Access Compliance Report

Public Rights-of-Way

(Curb Ramps)

Intersection ID: 14941	Main Street: BENJAMIN_ST	Cross Street: S_TRYON_ST	Location: W
ADA ID: 701EEEB522EE	Ramp Type: PerpDiag	Initial Pass/Fail: Fail	Overall Compliance: No
Severity Score: 13.75			
Codes/Mitigation Info/Possible Solution		Field Measurements/Component Compliance

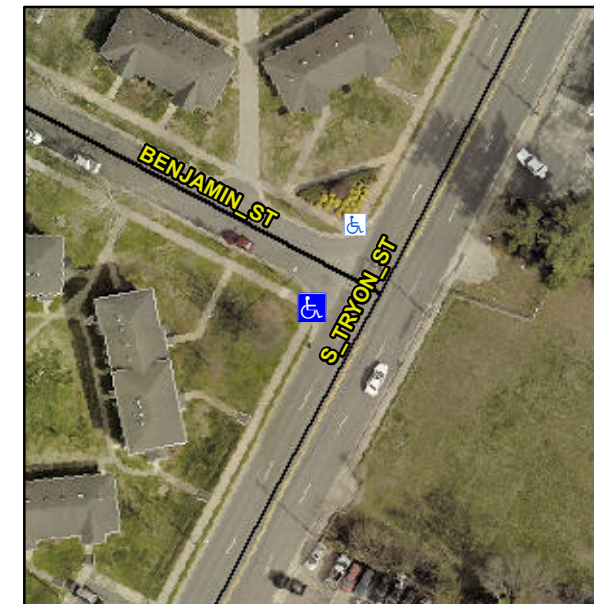
Not Found, R304.2.2, R304.5.3

Compliance	Description	Data	Compliance	Description	Data
N/A	Ramp Length (in)	58.0	No	Ramp Slope (%)	8.7
Yes	Ramp Width (in)	48.0	No	Ramp XSlope (%)	2.1
N/A	Flare Type LT	N/A	N/A	Flare Type RT	N/A
N/A	Flare Slope LT (%)	N/A	N/A	Flare Slope RT (%)	N/A
N/A	Flare Traversable LT?	N/A	N/A	Flare Traversable RT?	N/A
N/A	Landing Length (in)	N/A	N/A	DWS Provided?	N/A
N/A	Landing Width (in)	N/A	N/A	DWS Contrast?	N/A
N/A	Landing Slope (%)	N/A	N/A	DWS Length (in)	N/A
N/A	Landing X Slope (%)	N/A	N/A	DWS Full Width?	N/A
N/A	Landing Curb? (Y/N)	N/A	N/A	DWS Offset (in)	N/A
N/A	Shared Landing?	N/A			
N/A	Gutter Ponding?	N/A	N/A	Gutter Slope (%)	N/A
N/A	Gutter Lip Ht (in)	N/A	N/A	Gutter X Slope (%)	N/A
N/A	Painted X Walk1?	No	N/A	Painted X Walk2?	No
	X Walk 1 Direction	To SE		X Walk 2 Direction	To NE
N/A	X Walk 1 Width (in)	N/A	N/A	X Walk 2 Width (in)	N/A
	X Walk 1 Slope (%)	0.4		X Walk 2 Slope (%)	2.6
	X Walk 1 X Slope (%)	2.4		X Walk 2 X Slope (%)	1.7

Remove & Replace Curb Ramp With Two New Directional Ramps or Equivalent.
